City of Cambridge

CALENDAR ITEM # 1

ORDERED: That the Commissioner of Public Works be authorized to construct curb cuts over sidewalks in front of estates upon the streets as hereinafter named, the expense thereof to be charged to the appropriation for Public Works Department, Paving (Edgestones and Sidewalks). The entire cost of material and labor furnished to be repaid to the City by the owners of abutting estates.

SUBJECT: Curb Cut at 20 Shepard Street, Cambridge, MA.

Proposed
Driveway.

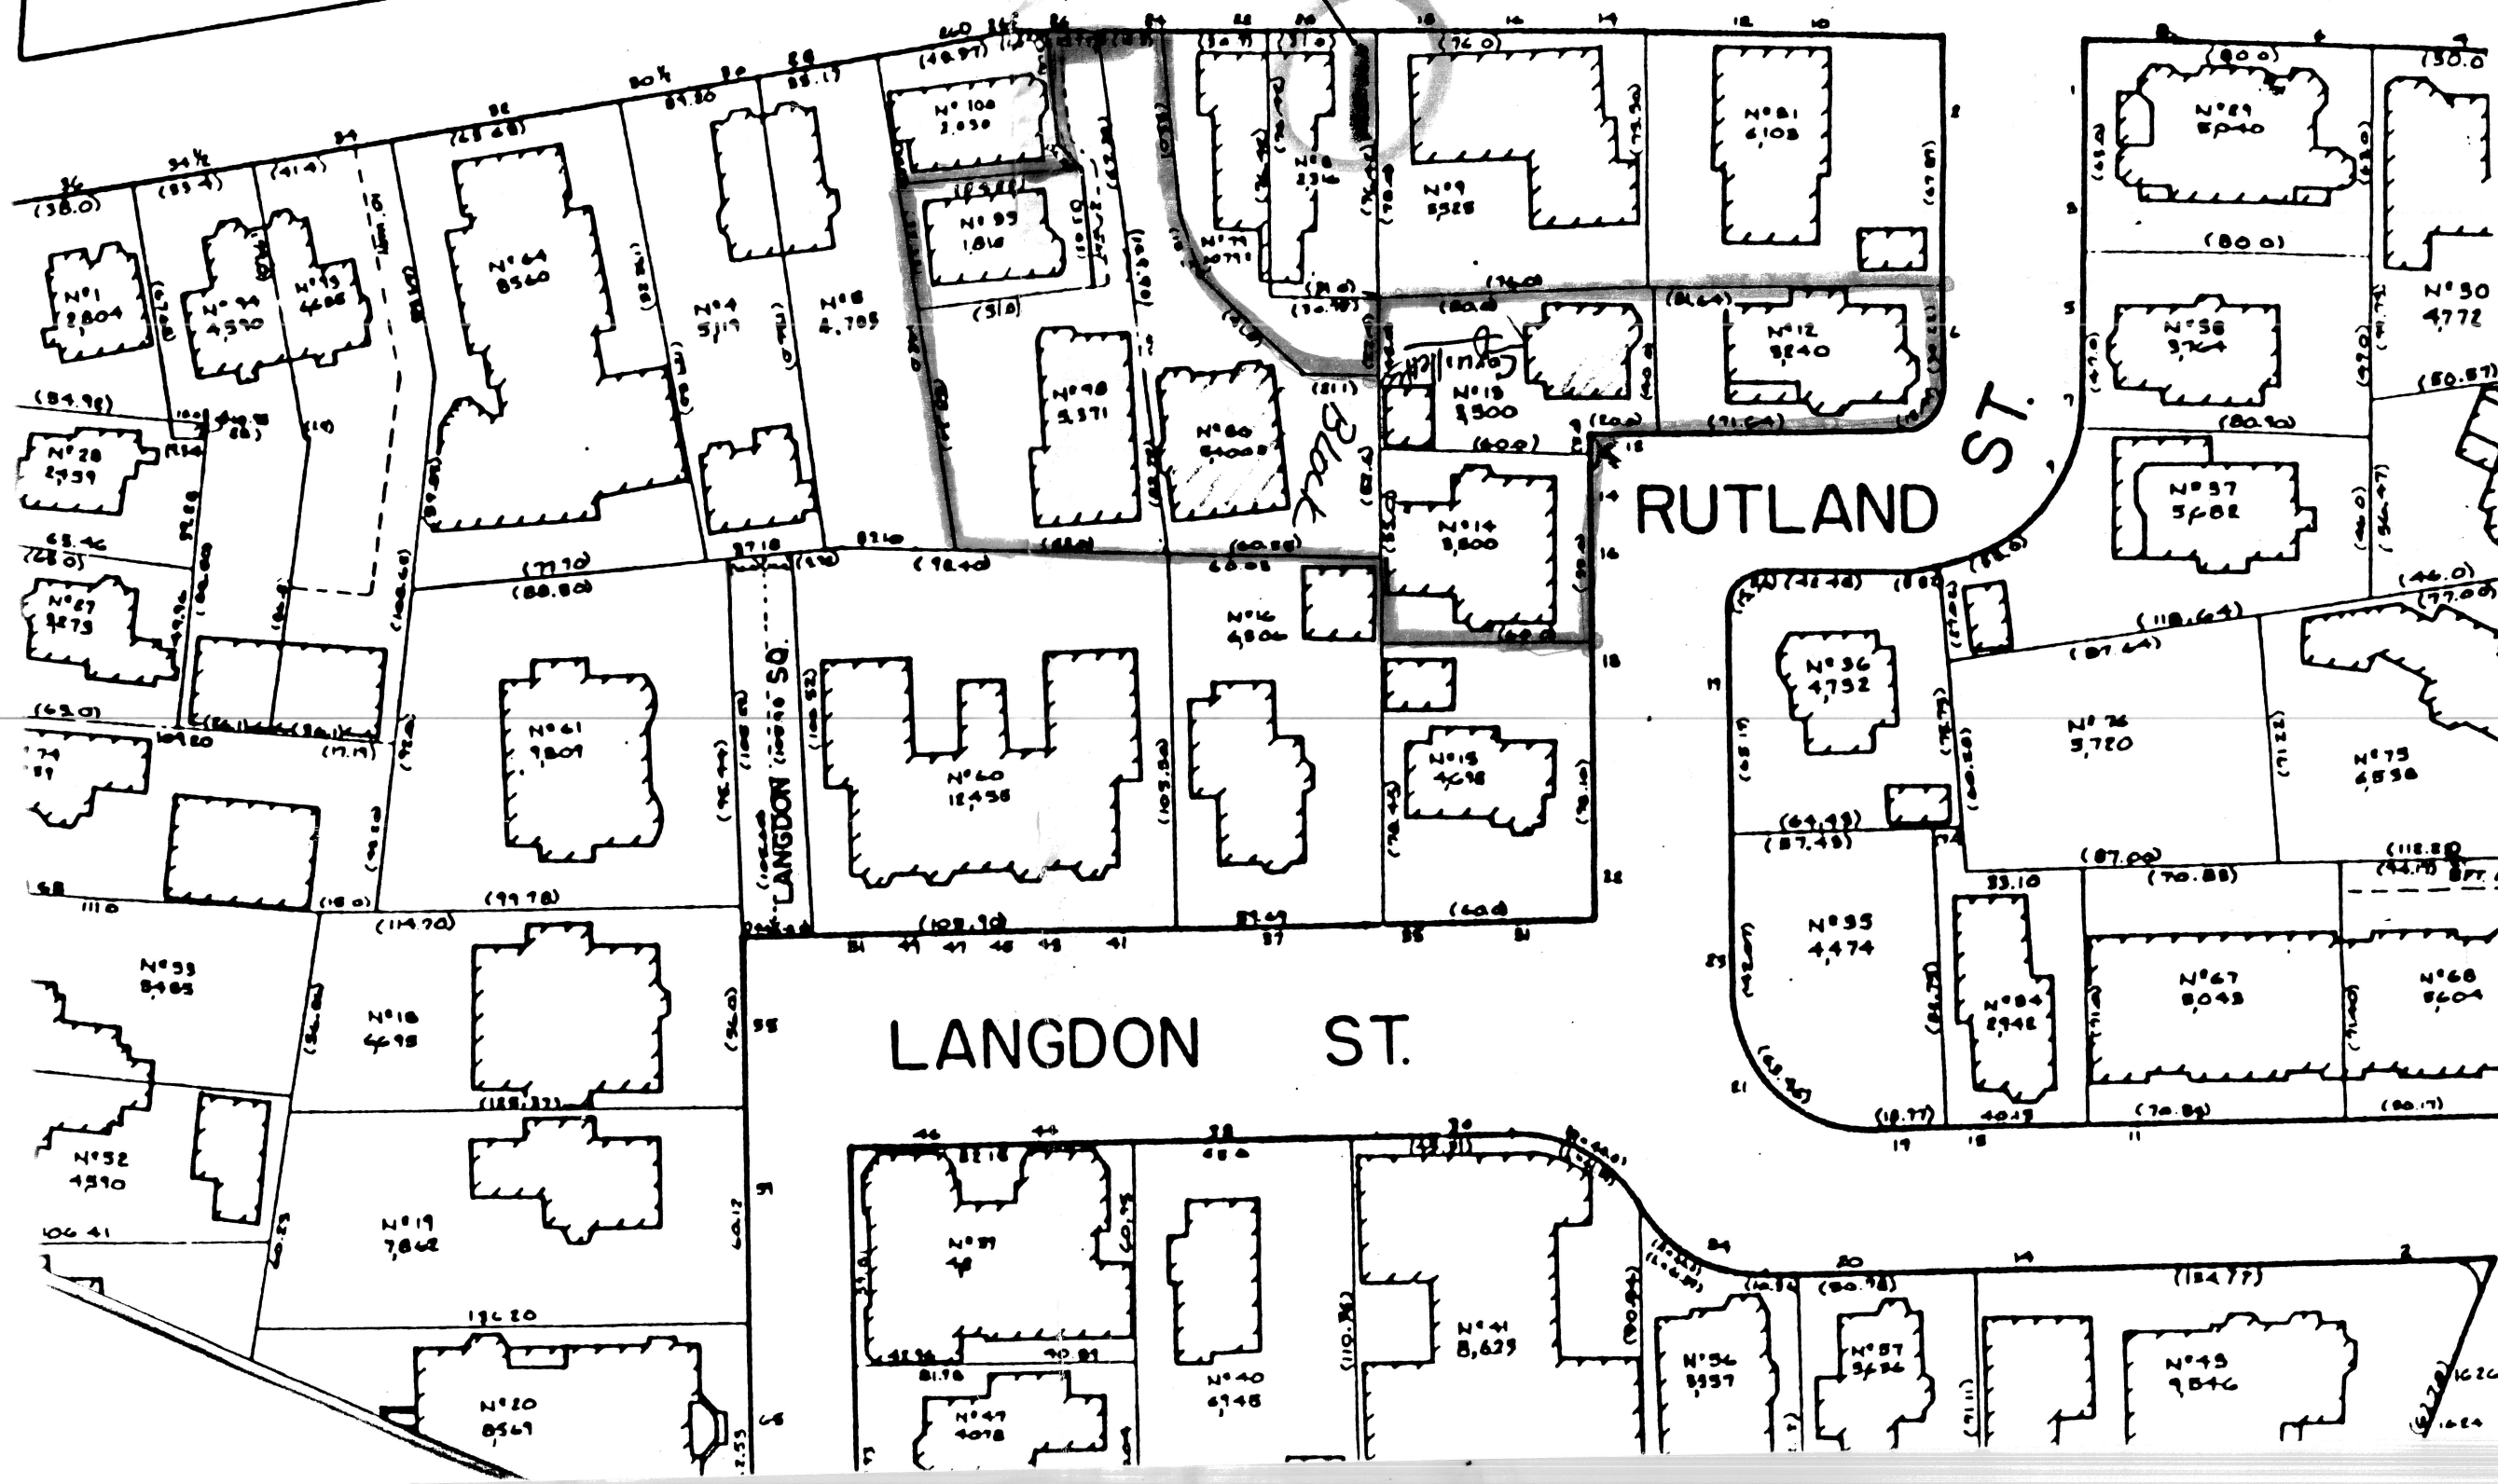
- = opposed

COMPILED
PLAN SHOWING EASEM
CAMBRIDGE, MA:

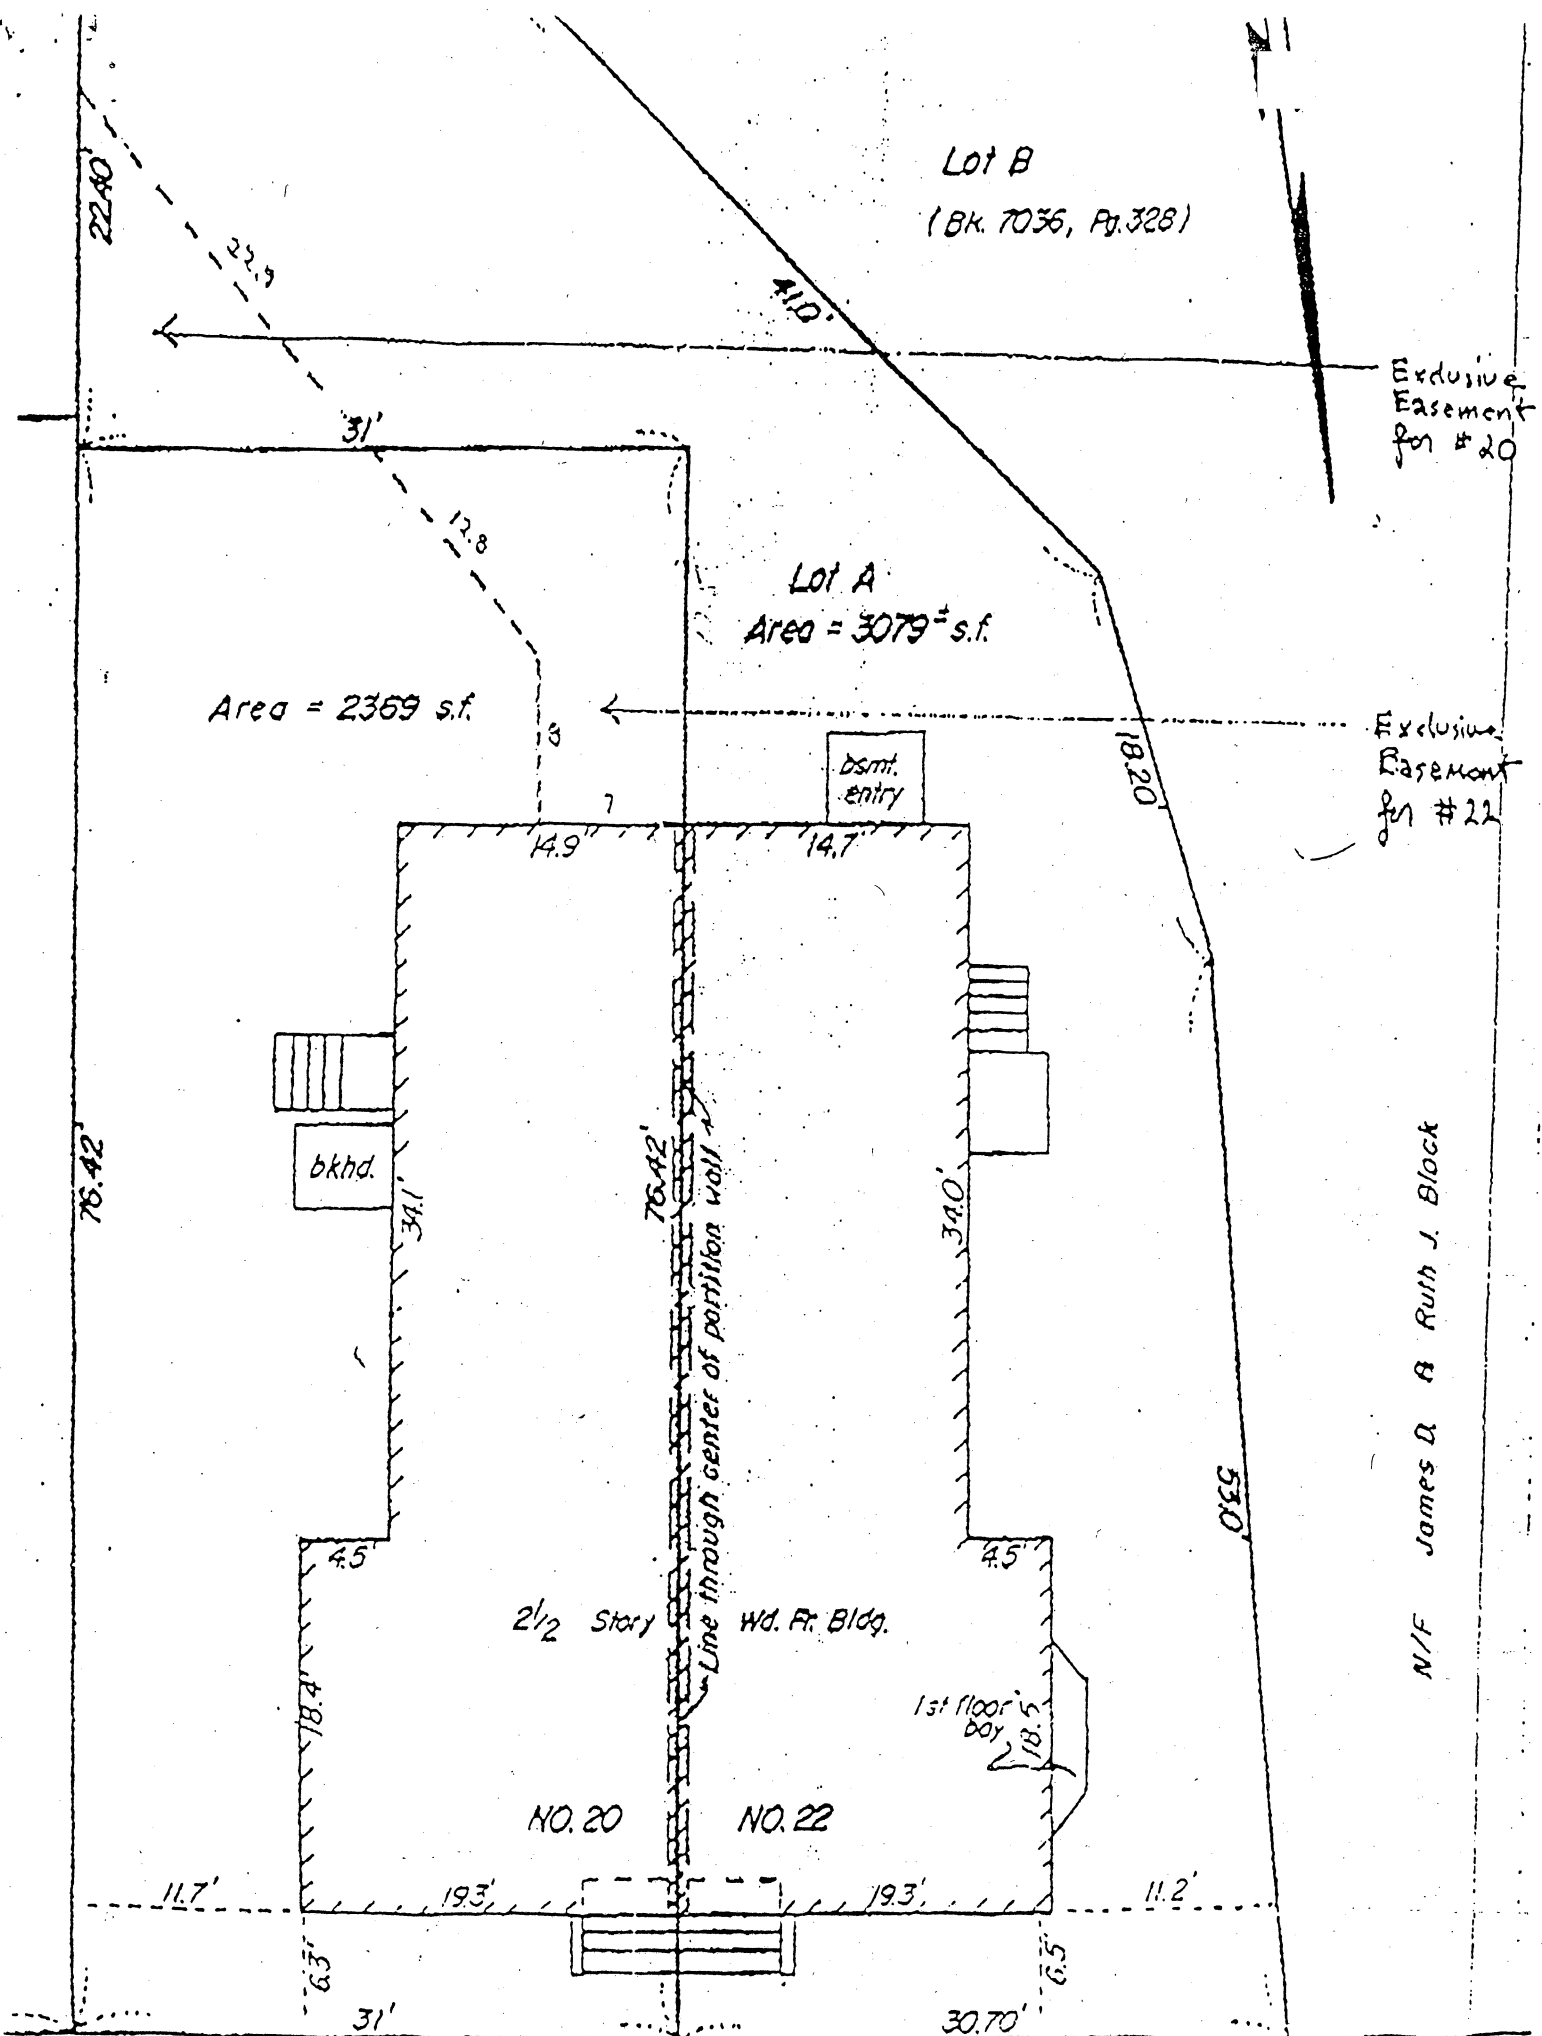
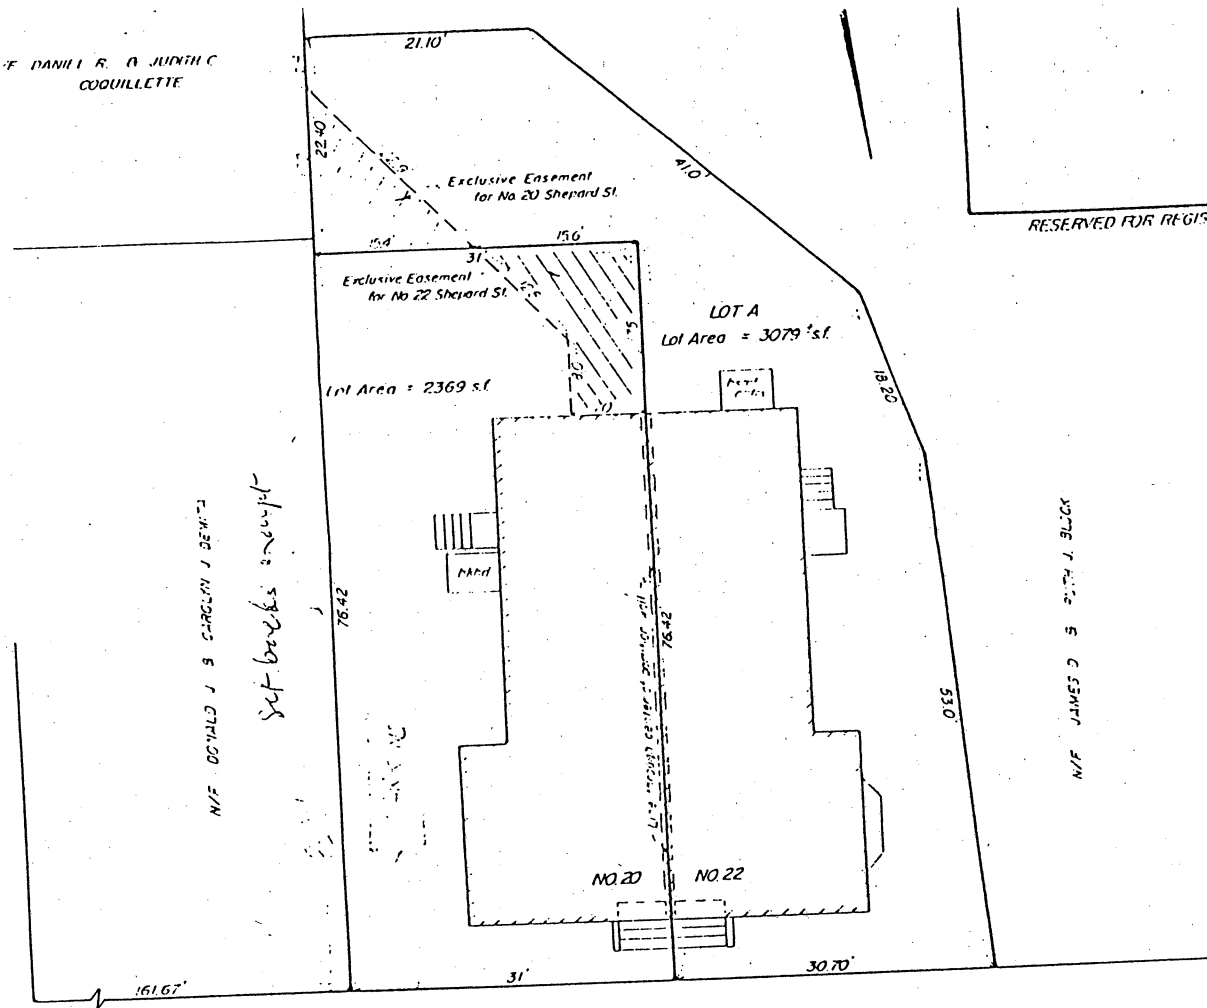
We the undersigned protest the issuance of a curb cut to Madlyn Shanel at 20 Shepard Street. Ms Shanel's parking site does not comply with zoning requirements and therefore requires a variance. Application for a variance has not been made making the issuance of a curb cut illegal.

The proposed parking is in violation for following reasons:

1. Inability of the new parking configuration to meet current parking standards per zoning sections 6.41 to 6.477 related to new parking spaces and standards.

- A) Sections 6.432 does not allow tandem parking for two different dwelling units.
 - B) Section 6.441a does not allow parking withing 5' of a wall with windows of occupiable rooms. (This relates to fumes and noise factors)

- C) Section 6.44b does not allow parking without a 5'0 buffer at side lot line.
 - D) Section 6.477 does not allow parking to impinge on front yard public space. (The proposed parking strip effectively extends the street into the private residential space with no proper buffer or separation--a row of brick etc. would not provide an effective separation.)

- E) Section 6.471 does not allow parking without screening. The section is very specific. The proposed 7" between edge of parking and lot line, for example, does not provide the 5'0" requirement for densely planted buffer.

- F) The parking would extend into the current front yard setback (of minimum 10' at pre-existing building)
2. The parking would be an exterior change to a non-conforming building per zoning section 5.30. The present building does not meet current standards regarding:

1. A) The applicant intends to park only one car, and there is no tandem parking. Therefore Sec. 6.432 does not apply.
- B) Section 6.441.A permits 1,2 or 3 family to park within 5' of a wall containing windows. (The Planning Board is working on changing this section).

- C) Section 6.441.B exempts 1,2 or 3 family from setbacks on side property line.
- D) Section 6.477 does not apply because section 6.47 applies to lot's containing more than five spaces, further no front yard parking is allowed by 6.441.C and the applicant is proposing to park beyond the 15' front yard setback.

- E) Section 6.471, applies to parking lots more than 5 spaces.
- F) The parking is only for one car, the application shown 33' long, that is 15' setback and 18' for standard size parking.

2. The section 5.30 of the Cambridge Zoning Ordinance deals with dimensional standards required for building construction.
3. There is an attached plot plan showing the dimensions of the property.

While that is a correct recitation of Section 6.432, it has no application to this curb cut request. The property owner does not seek parking for two vehicles in this driveway, nor will the driveway serve two different dwelling units. Accordingly, tandem parking is not an issue.

The parking will not extend into the current front yard setback. The parking will extend well beyond the 10 foot minimum requirement. (See response to paragraph D above).

The applicant has retained a landscape architect and provided a detailed plan depicting the appearance of the driveway and the parking space. A plot plan has also been submitted with the application identifying the specific location of the existing structures. (See attached).
